# UNITED STATES PATENT AND TRADEMARK OFFICE

APPLICATION NO.	FILING DATE	FIRST NAMED INVENTOR	ATTORNEY DOCKET NO.	CONFIRMATION NO.
10/578,488	12/18/2006	Aaron David McKenny	TRWZ 2 00283	9420
27885	7590	02/03/2011	EXAMINER	
FAY SHARPE LLP 1228 Euclid Avenue, 5th Floor The Halle Building Cleveland, OH 44115			NGUYEN, TUAN N	
			ART UNIT	PAPER NUMBER
			3751	
			MAIL DATE	DELIVERY MODE
			02/03/2011	PAPER

## Office Action Summary

## **DETAILED ACTION**

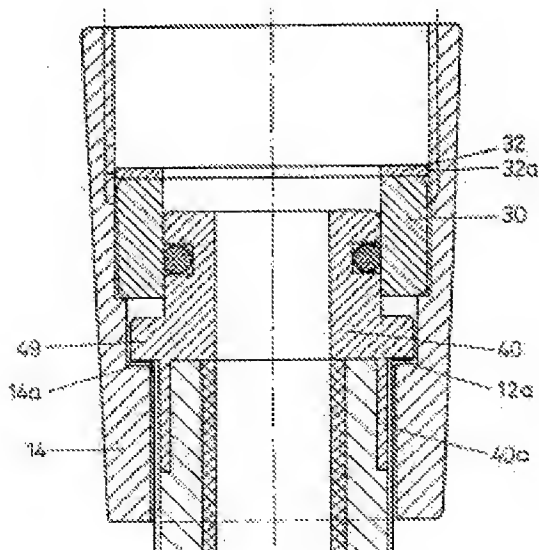
7. Claims 1-21 are rejected under 35 U.S.C. 102(b) as being anticipated by DE 29506835 (hereinafter Friedhelm).

Friedhelm discloses a hose and a connector and a fastener as claimed capable of being connected to a shower base unit and a shower head unit.

First member (40); second member (30); and seal (32).
